Kingswells
Community Council

Response to planning application 121759 -

Hotel and associated conference facilities,
Phase 2, Prime Four Business Park
Kingswells Aberdeen

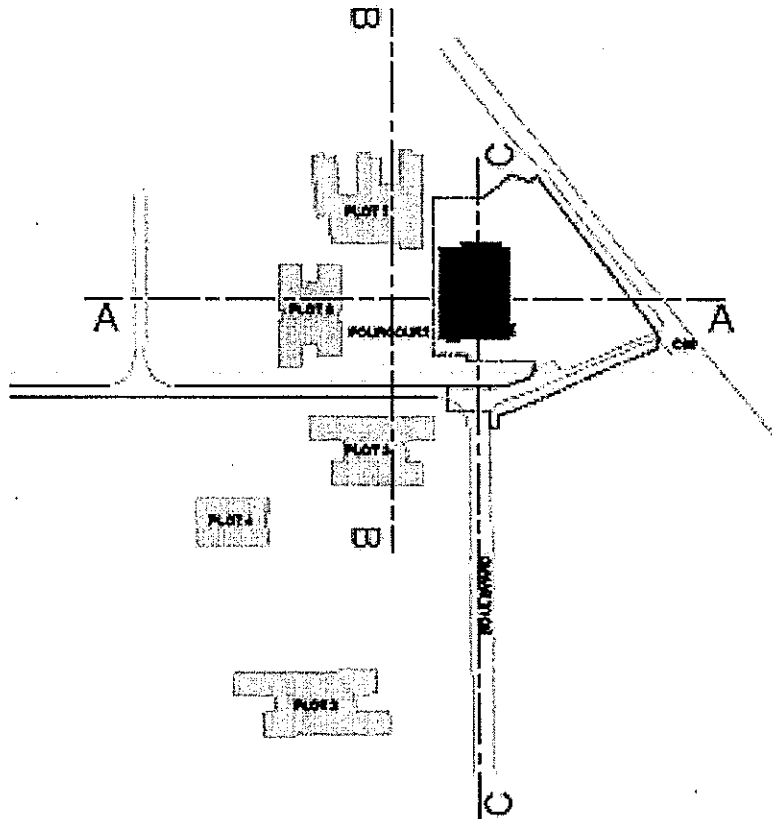
The site layout is shown here.

Plots 2, 3 and 4 are currently under construction.

Plot 6 and 7 are future developments and no plans are currently available.

The view looking from the north should be onto buildings with max 2 storeys; but Plot 7 appears to have 3. The profile is also supposed to be narrow side on to minimise the visual impact. Plot 7 is actually wider than it is long. It would appear to disregard 2 of the criteria for buildings on the northern boundary.

Plot 6 and the proposed hotel are about the same distance from the Consumption Dyke. Plot 6 is also 3 storeys.

Plots 6 and 7 are both effectively on the crest of the hill and are 1 storey higher than permitted by the masterplan. They effectively form a solid wall when viewed from the north. The hotel is 1 storey higher than both. It would appear that the hotel is being surrounded by buildings that are taller than permitted by the masterplan to make it appear more acceptable. If plots 6 and 7 complied with the masterplan then the proposed hotel would be 2 stories higher than the surrounding buildings. Having a hotel that sticks out like a sore thumb would not be acceptable to Kingswells, nor would having all buildings on the crest of the hill taller than that permitted by the masterplan.

Plot 3 is the Transocean building. Although it is built on the south side of the hill, currently the upper 2 storeys can be seen from the North. According to the plan for the hotel 3 storeys will be seen after the earthworks for the hotel are complete.

Section A-A

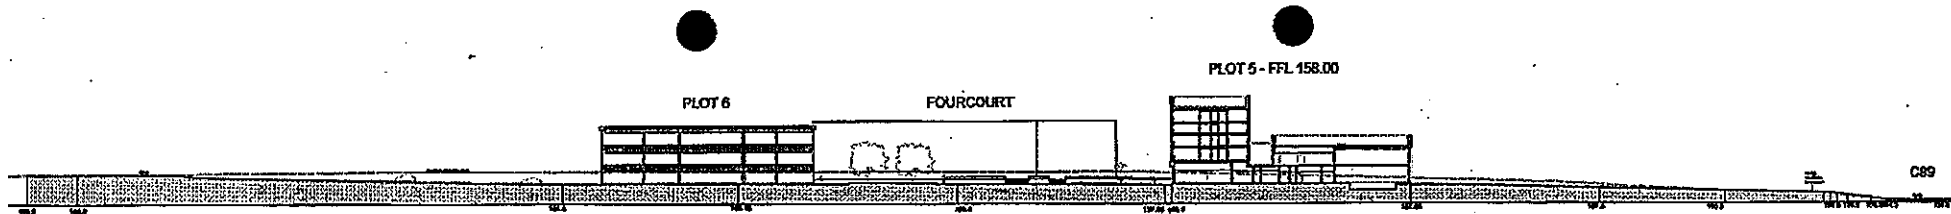
The height of the hotel should not be used as a precedent to determine the height of the surrounding buildings. The intention of the masterplan is clear. The visual impact from the north is important to maintain some degree of a 'sense of place' for the consumption dyke. Limiting the height of the buildings on the northern edge of the development to two storeys is good in principle, but if the buildings behind are taller than the perimeter buildings then the intention of the masterplan is lost. Tall buildings can only be accommodated where there is no visual impact from the north.
